TS-4900 iMX6 SBC

Rev.A --> Rev.C Changes

Rev.D changes:

Technologic Systems	Date Nov. 19, 2015
Title: TS-4900 MX6 SBC	
Rev: D	Designer
Sheet 0 of 15

Two 100-pin Off-board Connectors

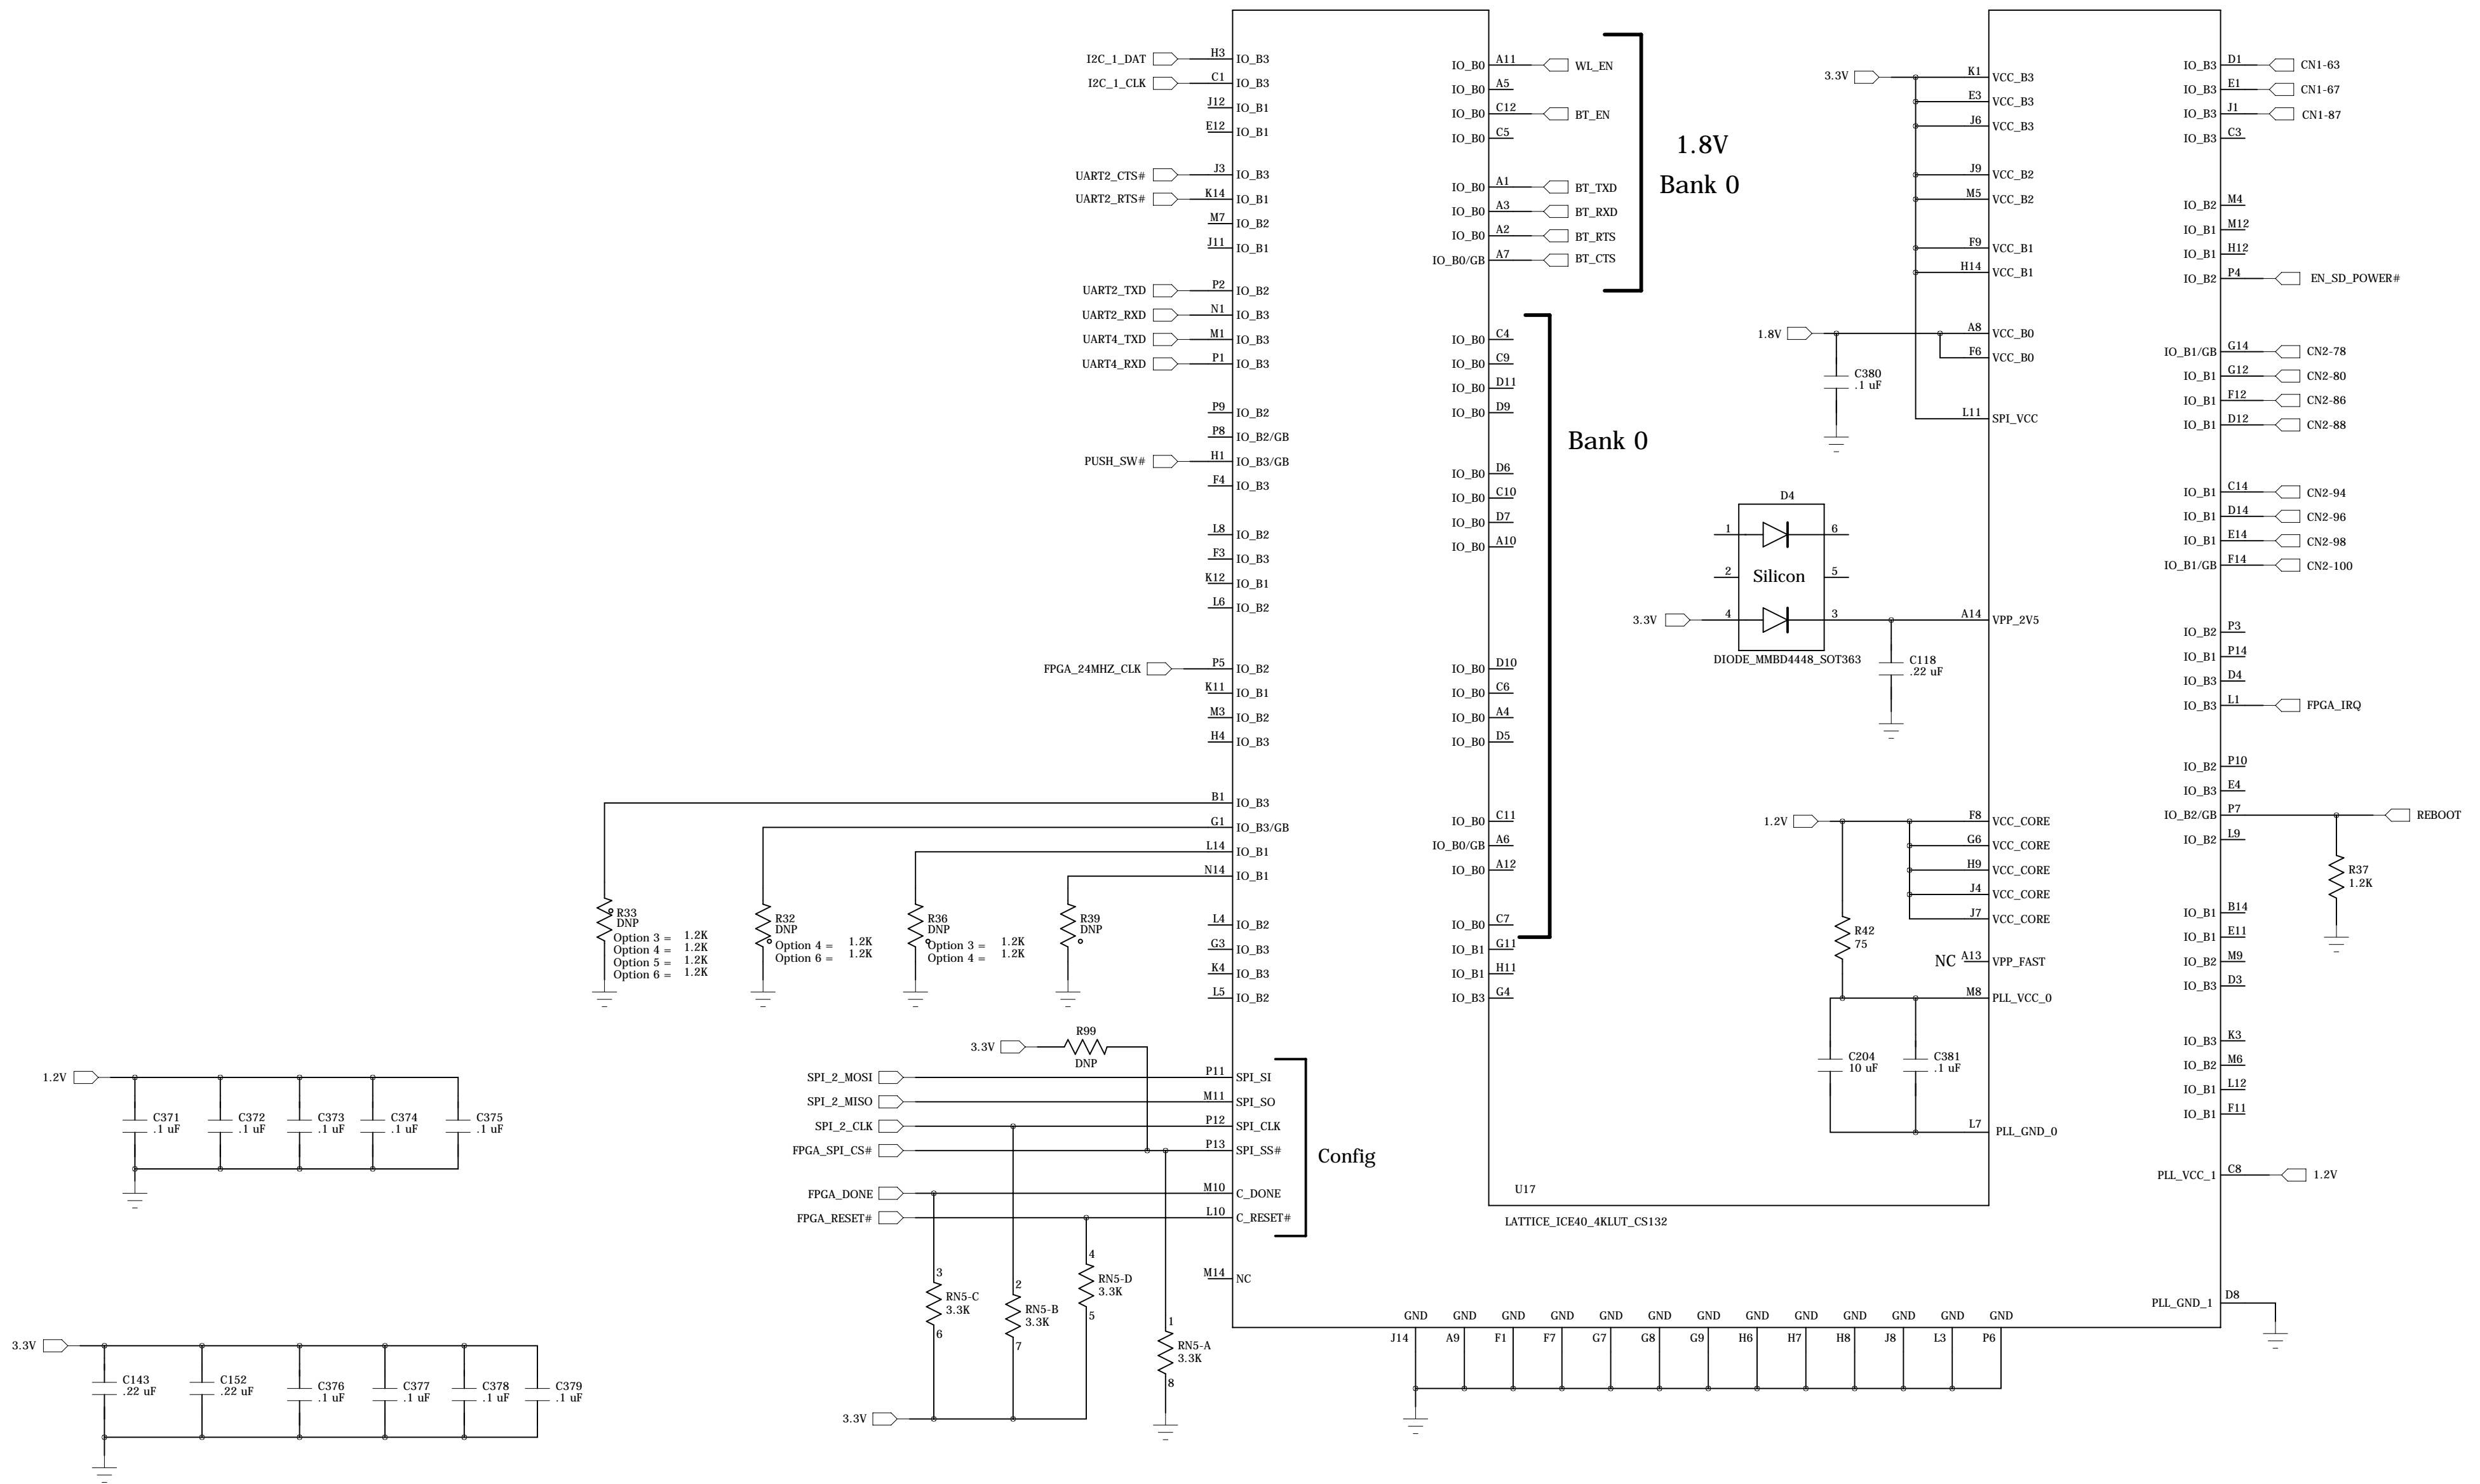
Rev.C Change
CN1-65 (DIO_10) and CN1-99 were swapped on CPU

Rev.C Change
CN2 pins 56, 58, and 60 are different iMX6 balls on Rev.C than on Rev.A
